**INFORMATION PAPER FOR  
ANTIQUITIES ADVISORY BOARD (AAB)**

**ARCHAEOLOGICAL WORK AT THE SACRED HILL AREA FOR  
THE SHATIN TO CENTRAL LINK (SCL) -  
TAI WAI TO HUNG HOM SECTION (TAW-HUH)**

Figure 1 *Enhanced monitoring scheme*

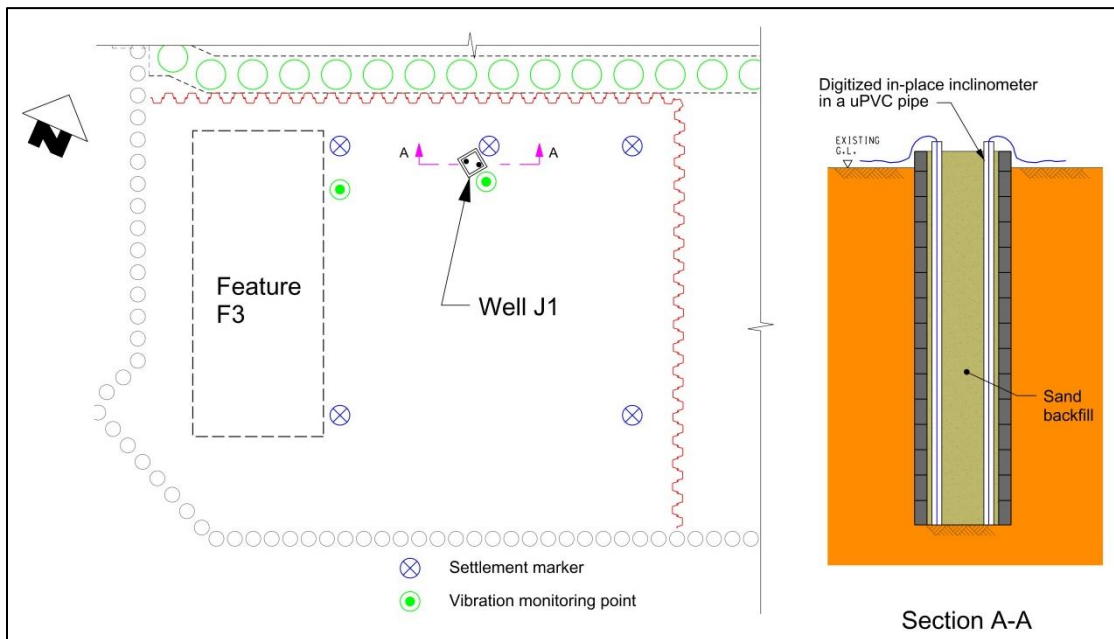
- c) More details should be given on the monitoring scheme on the stability of archaeological features, in particular the square-shaped well in T1.

- c) In addition to the proposed monitoring method by settlement and vibration monitoring points, more advanced technology should be applied to enhance the monitoring method for the stability of the square-shaped well during and after construction of the protection.

5.4 In response to the Development Bureau's request in 4.6(c), an enhanced monitoring scheme will be implemented as described in Fig. 1 to ensure minimal disturbance by adjacent SCL construction works to T1 area during and after installation of the protection wall proposed under Option 6. The enhanced monitoring scheme includes:

- a) 3D laser scanning carried out before any protection measure and thereafter to capture 3D models of the archaeological features for comparison to detect any significant distortion caused by the surrounding construction activities;
- b) 2 digital in-place inclinometers installed along the full depth of Well J1 to measure horizontal displacements;
- c) 5 ground settlement markers to measure any vertical displacement; and
- d) 2 vibration monitoring points to measure the vibration induced at Well J1 and feature F3.

Figure C1 Option 2 - Install pipe piles into bored piled wall

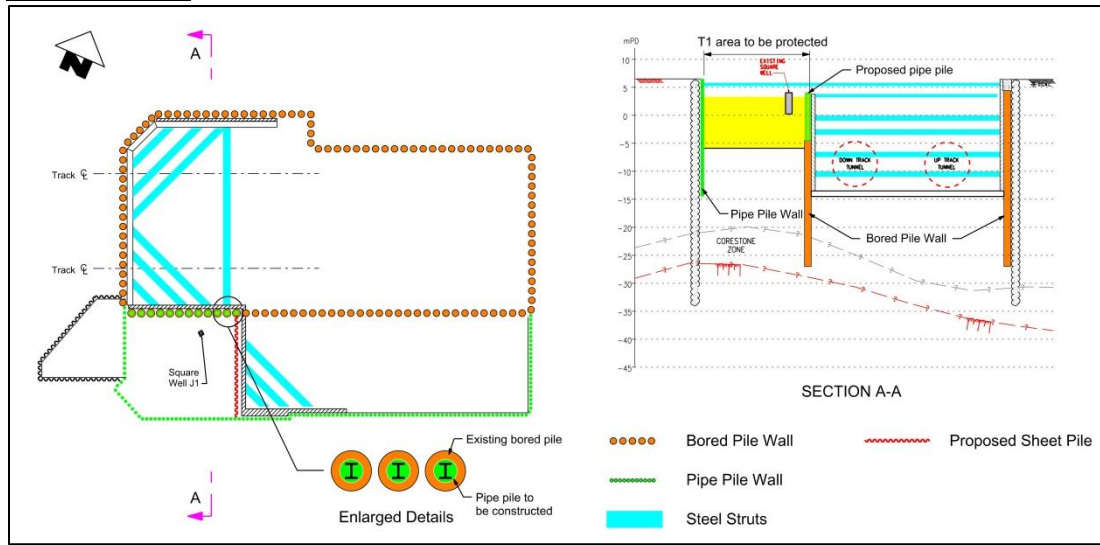
4.1	Option 1	To re-commence archaeological excavation in T1 in parallel with shaft excavation (not supported after AMO's meeting)
	Option 2	Install pipe piles at the existing bored pile wall along T1 Area
	Option 3	Install sheet piles at the north side of bored pile wall along T1 Area (distance of about 3.3m)
	Option 4	Install sheet piles at the north side of bored pile wall near the existing wall J1 (distance of about 3.3m) and other sheet piles installed at south side of bored pile wall
	Option 5	Reduce the size of the launching shaft so that it is entirely to the east of T1 Area
	Option 6	Install sheet piles at the south side of bored pile wall along T1 Area (closest distance of about 1.8m)

- The existing bored piles are quite heavily reinforced. The steel reinforcement of the bored piles will become obstructions that have to be overcome if the proposed pipe piles are to be anchored into the bored piles. The down-the-hole hammer technique used in the construction of pipe piles will not be able to overcome steel reinforcement. This technique will also generate large movement and vibration which may have adverse impact to the archaeological features in T1 area.

- A high degree of accuracy is required in the verticality control of the pipe pile construction to make sure that the pipe pile drilling which is to start at a level of +3 mPD will stay within the 1.2m dia bored pile at the cut off level of -4.4 mPD and below. It is also not possible to ascertain the as-built positions of the bored piles without first excavating and exposing the pile heads. Any off-centre drilling will be obstructed by steel reinforcement and cannot proceed.

In view of the lack of mitigation measures that can satisfactorily address the construction difficulties highlighted above, it is concluded that Option 2 is technically not feasible.

Figure D1 Option 3 - Sheet pile north of bored piled wall

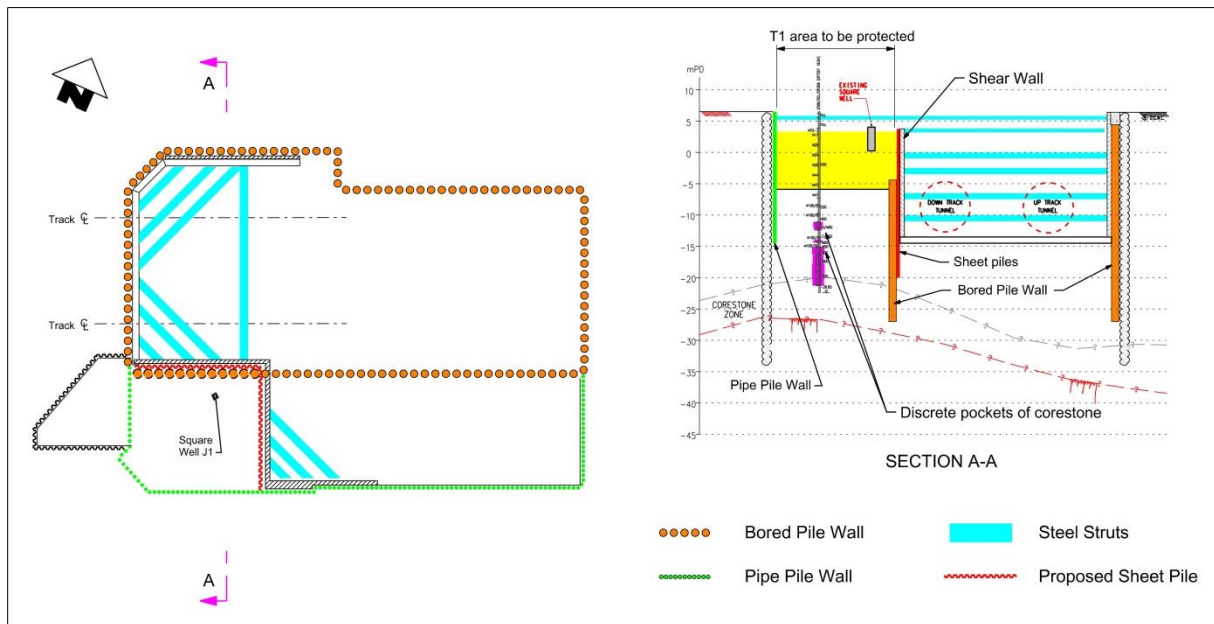
- 3.1 To review the T1 protection wall proposal and address the following concerns expressed by Members:
    - a) The distance of 1.8m between the sheet pile protection wall and the square-shaped well in T1 area is considered very close and that its installation may have adverse impact on the stability of the square-shaped well;

- 20m long sheet piles will have to be installed. Discrete pockets of corestones have been identified in the site investigation at a level of approximately -15 mPD and below. Pre-boring or pile installation methods other than Giken silent piler will have to be used to overcome the corestones. These other methods will cause larger ground disturbance than the Giken silent piler method.
- Installation of longer sheet piles into stiffer ground will require higher operating force and increase the potential impact to T1 area.
- Installation of sheet piles north of the existing bored piled wall will decrease the working space available for TBM installation. Adequate access width to meet safety requirement can no longer be provided (see Fig. D2).

Option 3 is considered undesirable as pre-boring or pile installation methods other than Giken silent piler will have to be used to overcome corestones during sheet pile installation. These other methods will cause larger ground disturbance that may have adverse impact to the archaeological features in T1 area.

Figure D2 *Inadequate access width to meet safety requirement in Option 3*

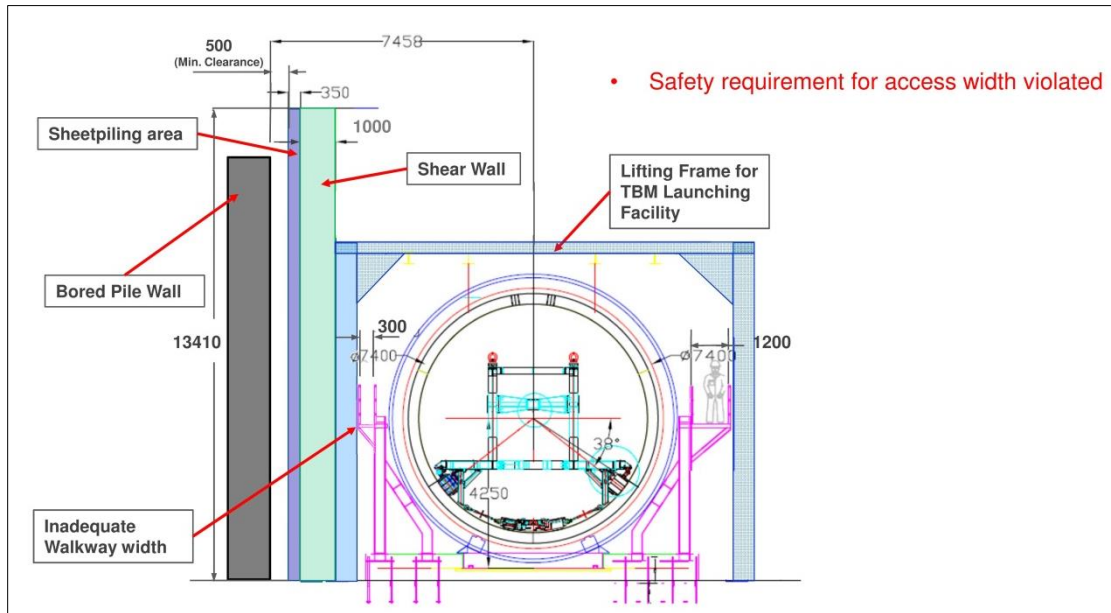
4.3 To address Members' concern in 3.1(a), Options 2, 3 and 4 gave a distance of more than 1.8m between the installed sheet piles and the square-shaped well. Option 2 was found not feasible; Options 3 and 4 require a deeper sheet pile installation which would encounter rock resulting in a more adverse impact on the archaeological features during installation. Options 3 and 4 will also result in an unsafe working condition for workers in the launching shaft area as it will reduce the width of the Tunnel Boring Machine (TBM) working platform from 1.2m to 0.3m.

Figure E1 *Option 4 - Sheet pile south of bored piled wall except for the 5m section nearest to the archaeological features*

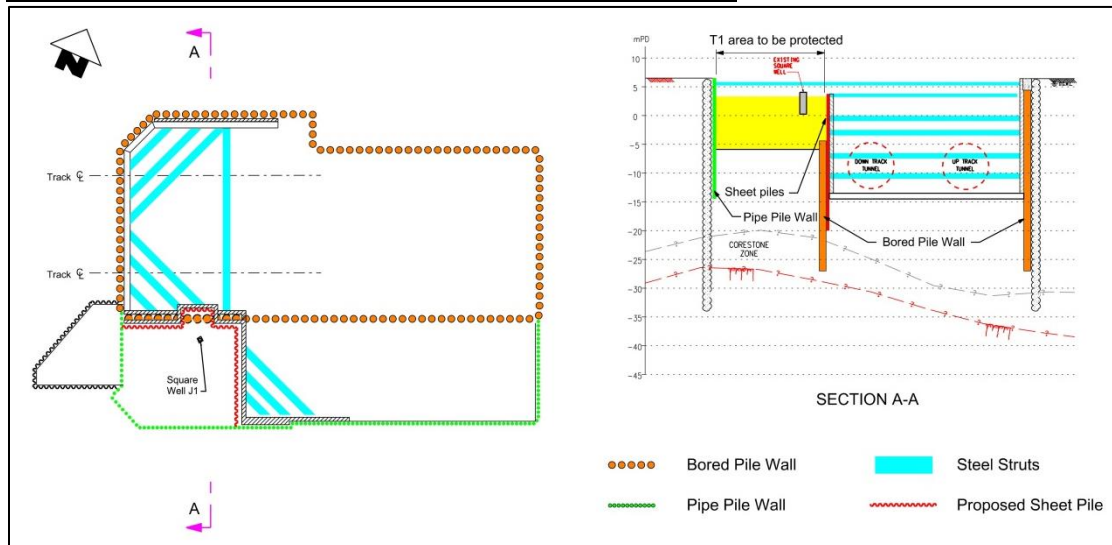
- a) The use of push-in sheet pile method (*Giken Silent Piler Method*) is a suitable method for installation of the protection wall.
  - b) The technical constraints that the sheet pile cannot be moved further from the 1.8m at the nearest location were confirmed valid and MTR was asked to consider if the sheet piles could be moved further at the localized area of the Well J1 area (Option 4 as stated above was added and it was also discussed in the meeting).

- The chance of encountering corestones obstruction during installation of the 20m long sheet piles required along the 5m section north of the bored pile wall will still be significant.
- The shear wall required in front of the sheet pile protection wall to transfer the unbalanced overall lateral earth loads acting on the launching shaft will have an irregular pattern. The transfer of unbalanced overall lateral earth loads will thus be less effective, and may result in larger ground movement in T1 area.
- Adequate access width to meet safety requirement can still not be provided for TBM installation along the 5m section nearest to the archaeological features.

Option 4 is considered undesirable as similar to Option 3, pre-boring or pile installation methods other than Giken silent piler will have to be used to overcome corestones during installation of 20m long sheet piles.

Figure F1 *Option 5 - Shaft size reduction*

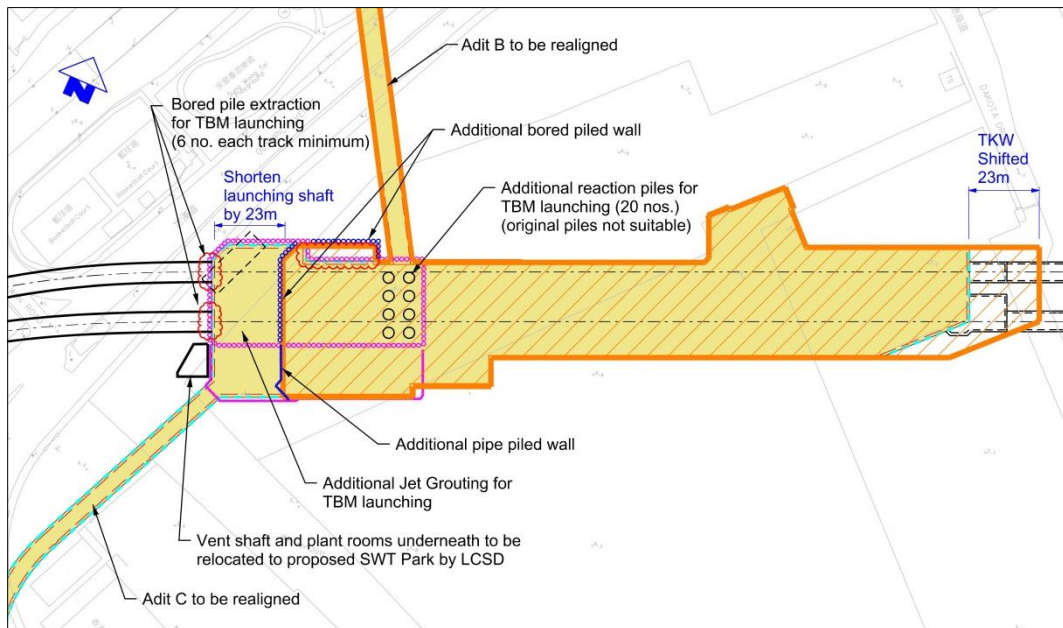
- b) Shifting of the launching shaft eastwards by 23m should be considered in order to keep T1 area away from the launching shaft construction activities; and

4.4 To address Members' concern in 3.1(b), Option 5 will reduce the size of the proposed launching shaft so that it is entirely to the east, just outside the T1 Area. The installed bored piles which form the current west headwall cross the TBM route. These will need to be removed. The removal of these bored piles will introduce significant impact on the stability of the existing archaeological features and impact an area not yet excavated. This is not acceptable in addition to significant time and cost impact.

- a) A considerable amount of time will have to be spent in the redesign of temporary and permanent works including the platform and the station.
- b) A considerable amount of completed works including bored piles, reaction piles and heavy duty steel struts will become abortive and have to be removed.
- c) Removal of bored piles will involve chiselling in close proximity to T1 area and may have adverse impact to the archaeological features located there.

Option 5 is considered undesirable as removal of bored piles may have adverse impact to the archaeological features in T1 area. This option will also have significant cost and time impact.
